MIAMI BEACH

Design Review Board

SUBJECT: DRB19-0396
1570 Alton Road "TD Bank"

DRB19-0396, 1570 Alton Road. An application has been filed requesting Design Review Approval for exterior alterations to an existing one-story building including new signage and modifications to the façade and a variance to exceed the maximum sign area for projecting signs.

Original building permit elevation drawings, DRB8080

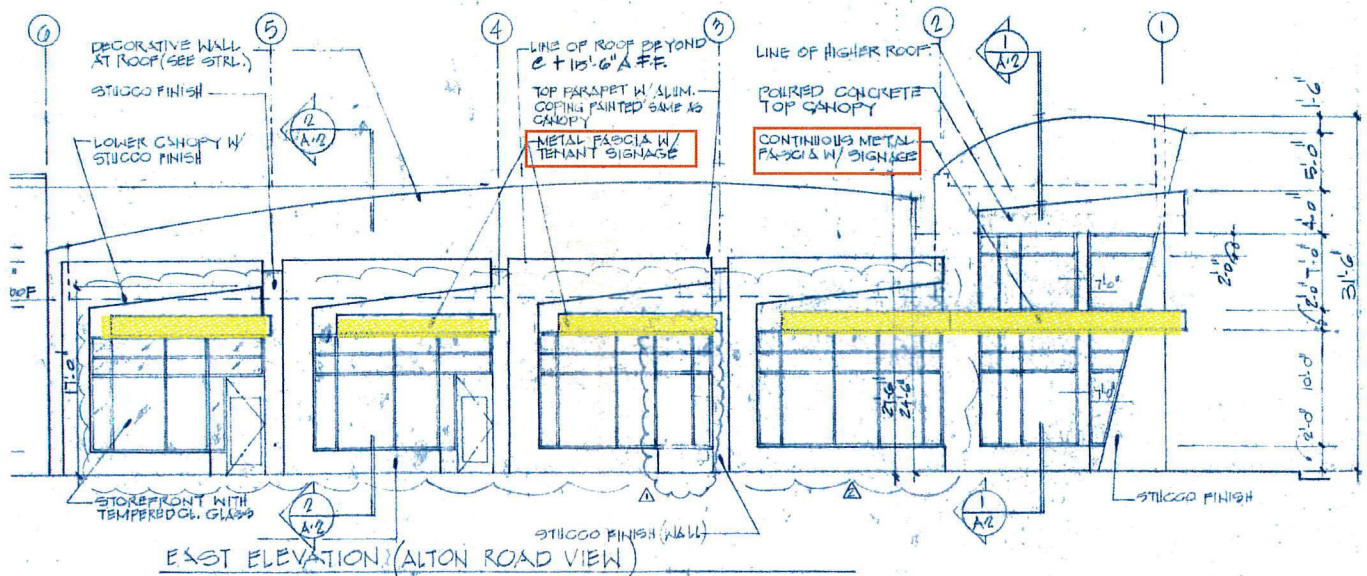
Staff's primary concerns with the application pertain to the awkward three-sided sign cube proposed to be suspended within the lower and upper canopies of the corner entrance. Staff has offered to work with the applicant to find alternate location that would be compliant with the sign code and more compatible with the existing structure.

From the 1996 staff report for DRB 8080,

"The elevations are highly contemporary in scope with each individual storefront incorporating decorative fin projections; the corner of the building is highlighted by upper and lower canopies. At the roof of the structure, a larger fin wall, which commences at the south side of the structure and spans the entire width of the building along Alton Road, gently rises in height and reaches a crescendo at the corner."

"Signs on the metal fascia may only be 15 s.f. (projecting sign)"

This clearly illustrates that the design intent of the metal fascia was to act as a sign band in order to provide uniformity to the contemporary commercial structure with the potential to contain multiple tenants.

Staff recommends that the box sign be eliminated altogether and that the main signage be redesigned as a single row of individual, reverse channel character letters with a brushed aluminum finish that can each be backlit along the metal fascia eyebrow element. Furthermore, the location of both the signs and the proposed fascia replacement may be outside the property lines and, if so, would require a revocable permit from the City Commission and an approval from the Public Works Department.
